Table 1: Response to issues raised by unidentified community members

Table 2: Response to issues raised by identified respondents

Response to review of odour impact assessment for Moira Feedlot by Pacific Air and Environment

Annual and seasonal windroses for Moirá by TAPM (Mar 2005 to Dec 2005)

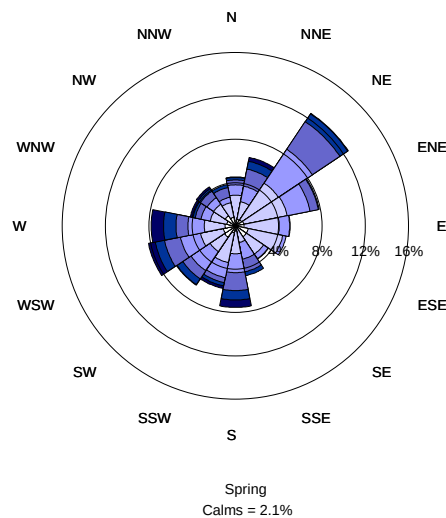
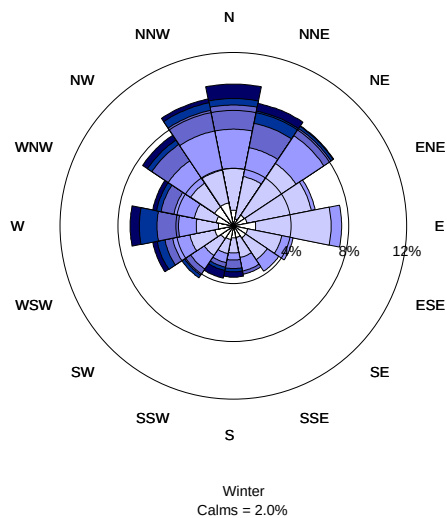
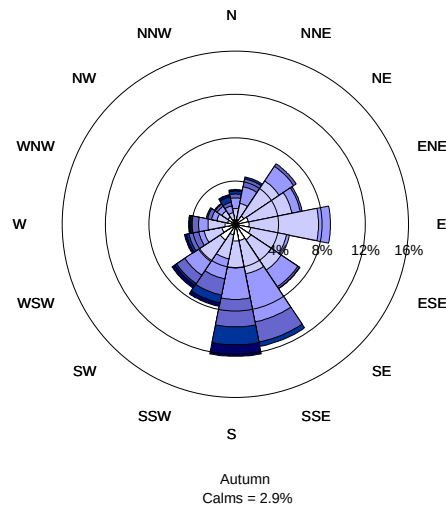
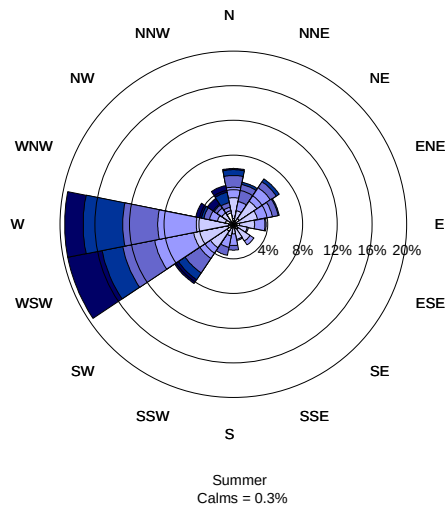
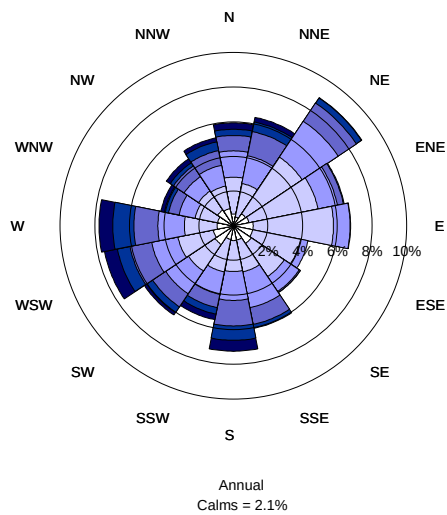
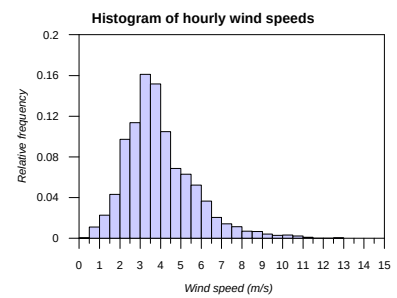
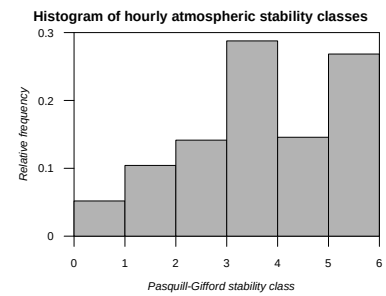
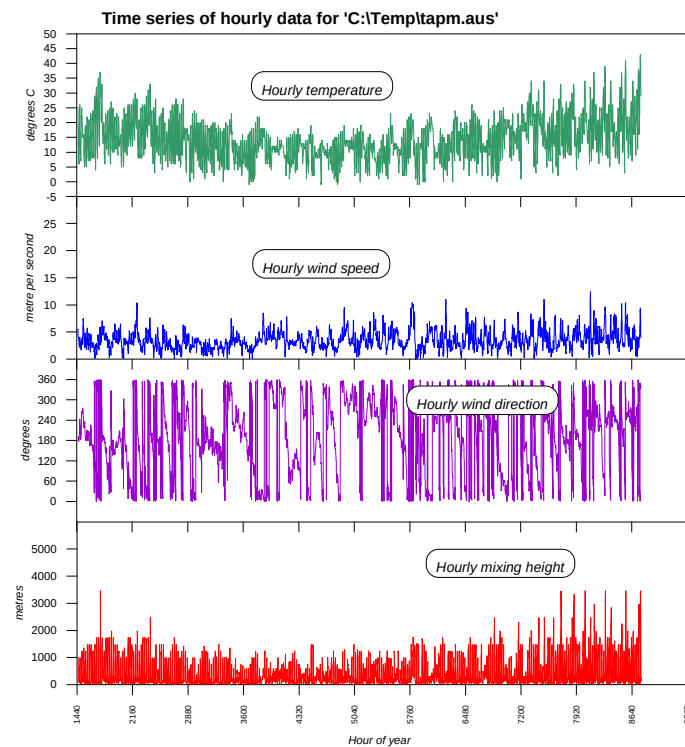
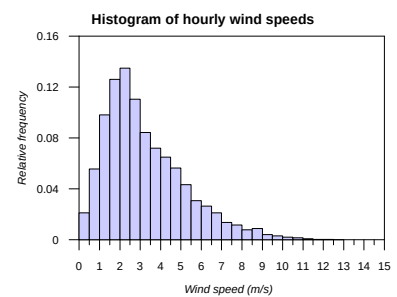
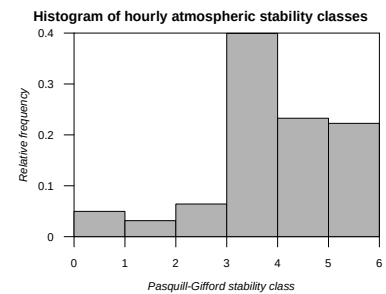
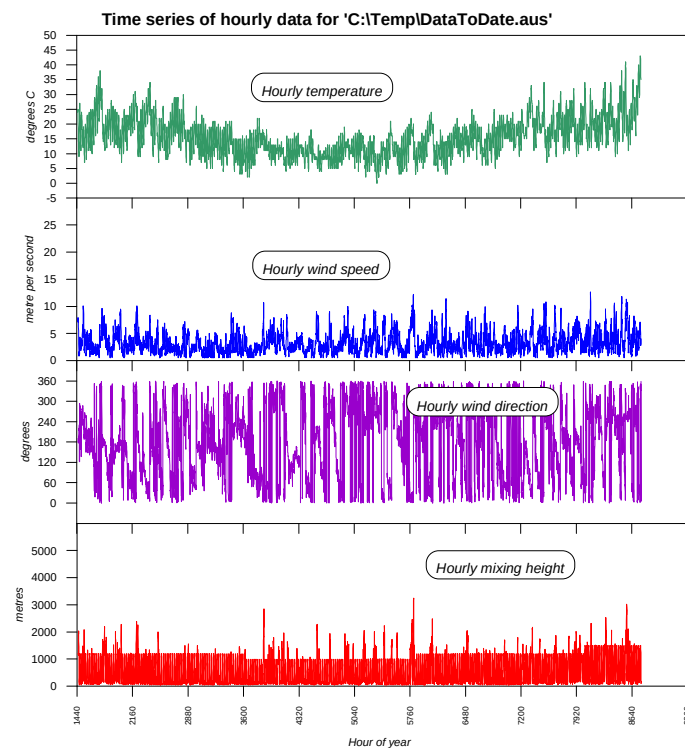
The comparison of the meteorological data records (presented in Appendix B of the assessment) was carried out on the information available at the time of the assessment. These records included data from the TAPM simulation for 2003, data from the on-site weather station for the period March to June 2005 and data collected at Deniliquin by the Bureau of Meteorology. There will be slight variations in meteorological records from year to year at any one site so the comparison generally focused on average wind speeds, annual percentage of calms and annual wind-roses. A useful outcome of the comparison was that the TAPM 2003 data were not vastly different from the available on-site data. Although the TAPM data were not considered the most ideal information for the assessment, the result of the comparison suggested that TAPM data were an adequate representation of the dispersion conditions in the area. The occurrence of very light winds was found to be higher in the on-site data than for the TAPM 2003 data. This suggests that possibly higher off-site odour concentrations would occur had the on-site data been available for use, however, the TAPM 2003 also had a higher percentage of F-class stabilities – also associated with conditions where high odour events are observed.

The collection of meteorological data at Moira has continued following the submission of the Environmental Assessment. Wind-roses and graphs have subsequently been prepared from data for a year 2005 TAPM simulation and on-site data collected in 2005. The wind-roses and graphs are provided below for comparison.

- Annual and seasonal wind-roses are considered to be similar for both the TAPM 2005 and Moira 2005 datasets
- The annual percentage of calms was 1.1% for the TAPM 2005 data and 2.1% for the Moira data.
- Annual average wind speeds were 3.5 and 3.3 m/s for the TAPM and Moira datasets respectively
- The TAPM 2005 data have a greater percentage of F-class stabilities while the Moira data have a greater percentage of D-class stabilities
- The frequency of light winds, say less than 2 m/s, is still slightly higher for the Moira data than for the TAPM data

While the concurrent TAPM and on-site data are still not identical, we consider that this comparison gives some more confidence in the performance of TAPM for the Moira area and reduces some of the uncertainty associated with the assessment.
